Date: April 4, 2024

To: Village of East Troy Plan Commission

From: Tim Schwecke, Zoning Administrator

Subject: Extraterritorial review of a three-lot certified survey map in Town of East Troy off of Weber Lane (PET 2300005); Frederick and Judith Kmiec, applicant

CERTIFIED SURVEY MAP NO. \_\_\_\_\_

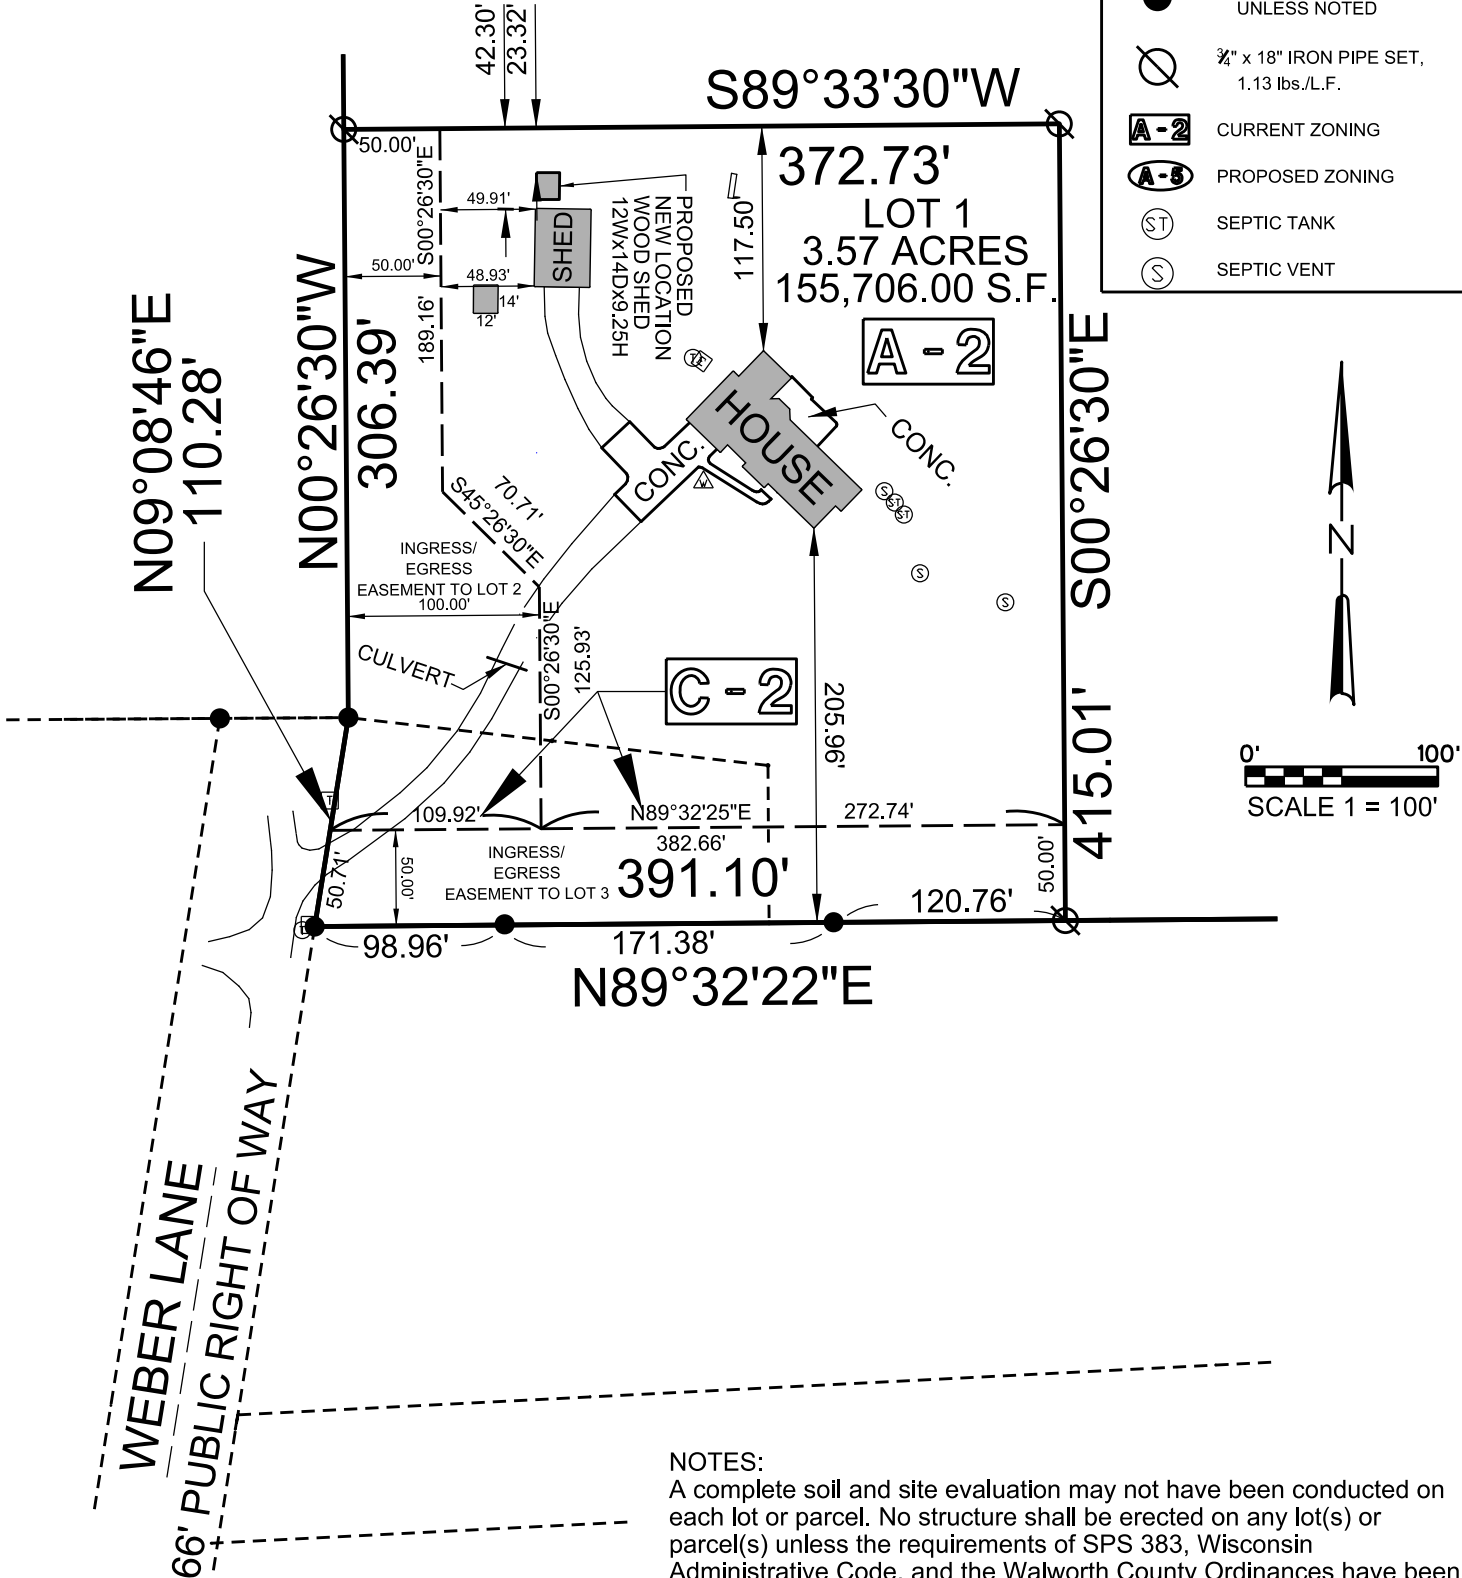
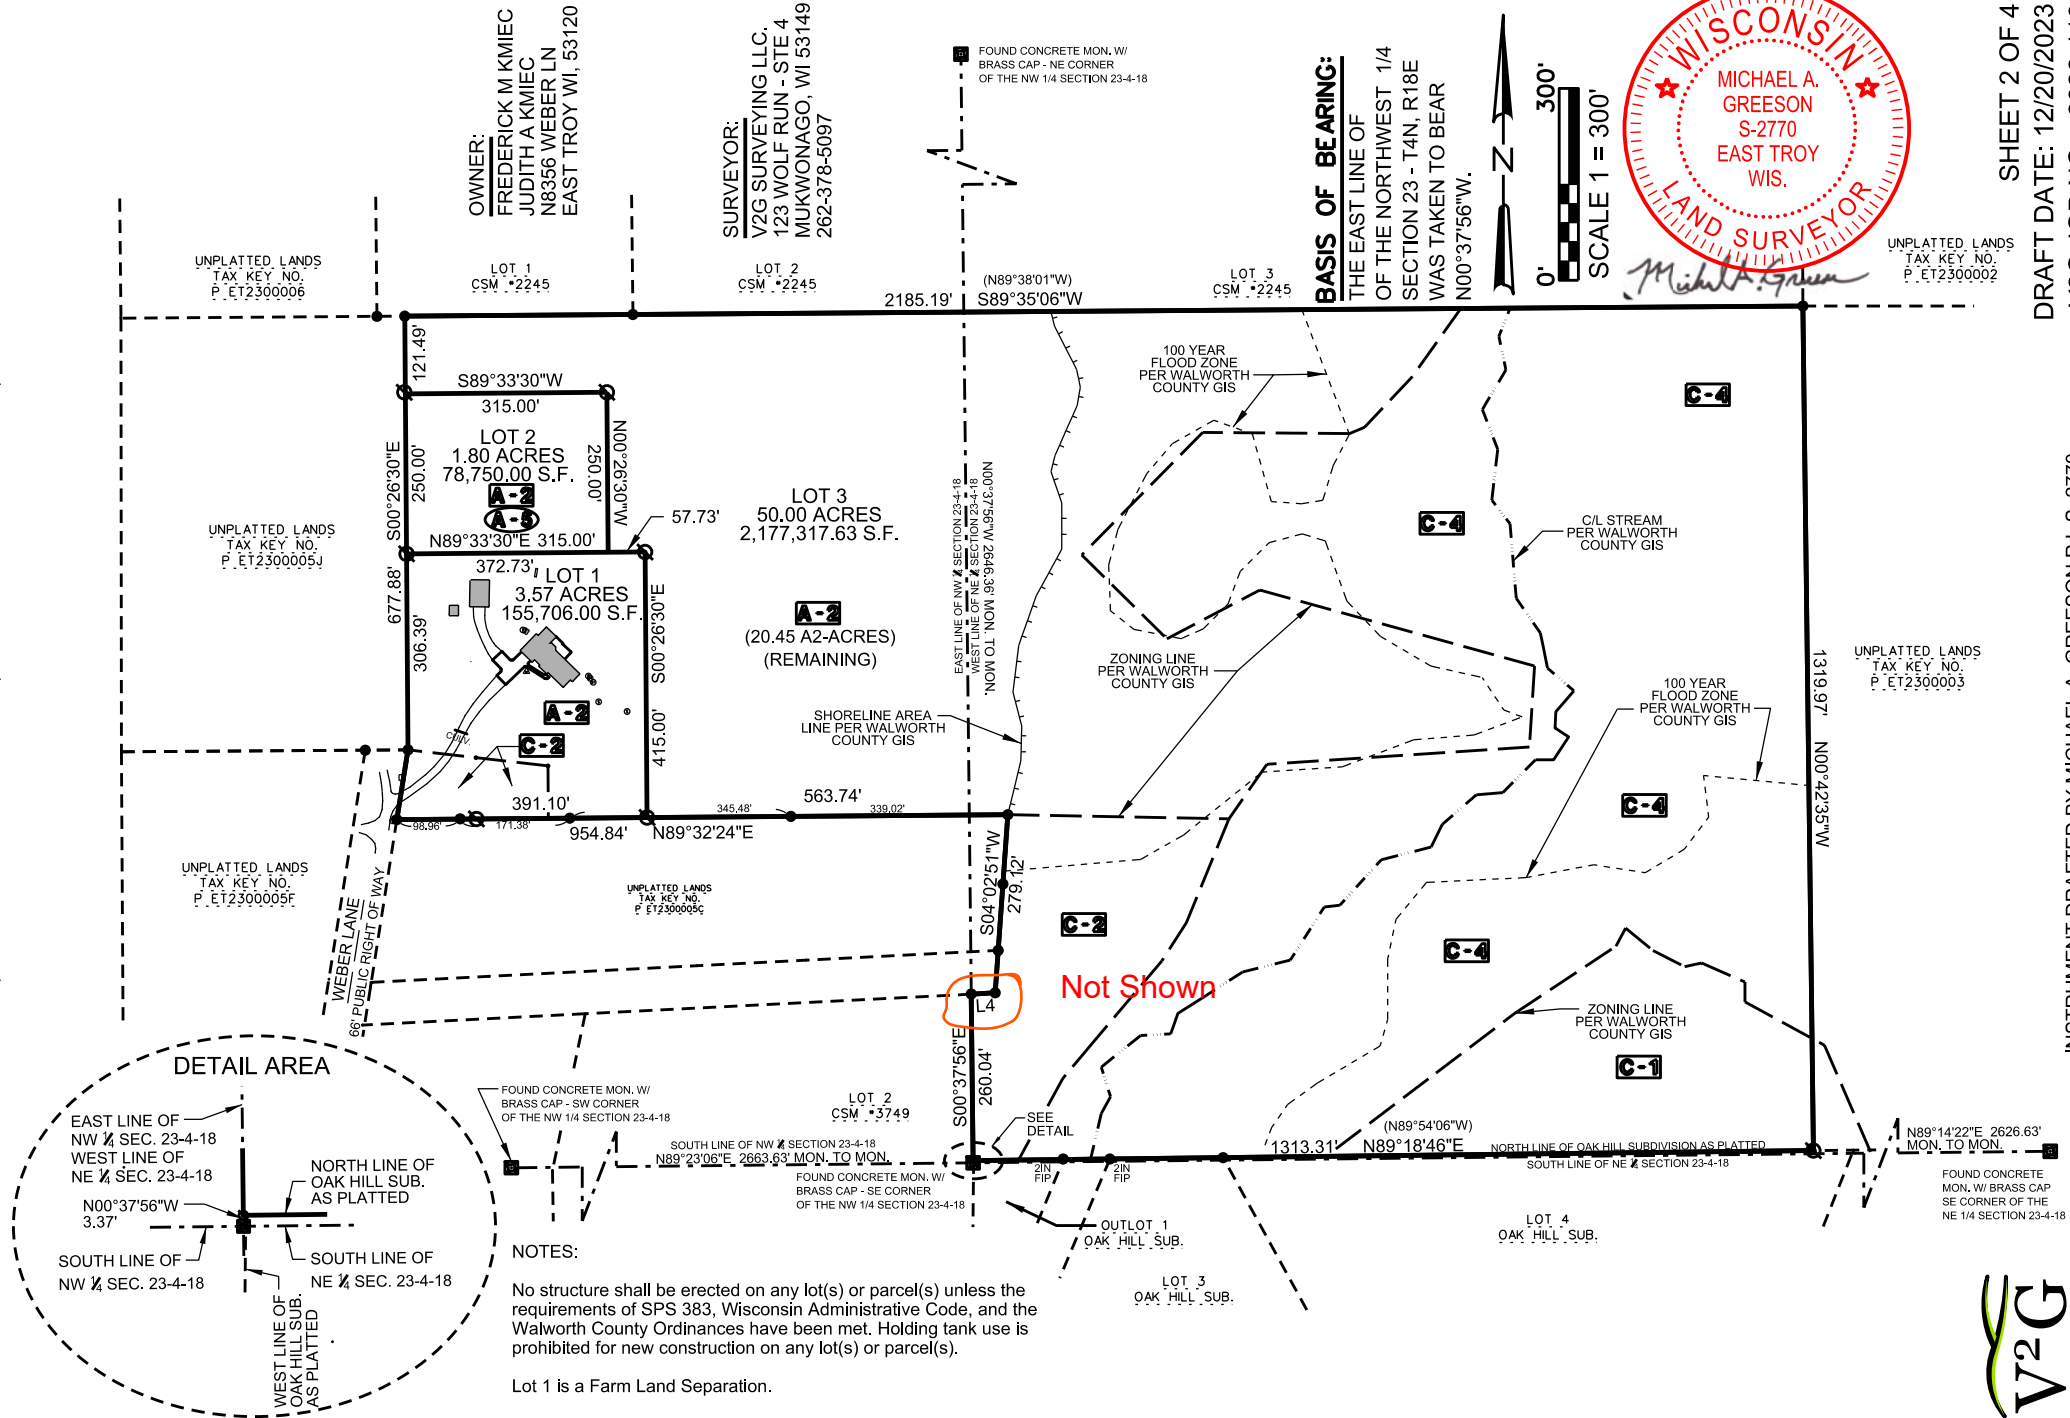
**Code compliance** Lot 2 and 3 do not front on a public road. The county and town will need to verify the lots comply.

1. Prior to the Village signing the final CSM, the property owner shall reimburse the Village of East Troy for all unpaid costs and expenses of any type that the Village incurs in connection with this development, including the cost of professional services incurred by the Village (including engineering, legal, planning and other consulting fees) for the review and preparation of required documents or attendance at meetings or other related professional services for this application.
2. The Town and Walworth County must verify Lot 2 and 3 have legal access and otherwise comply with zoning requirements.
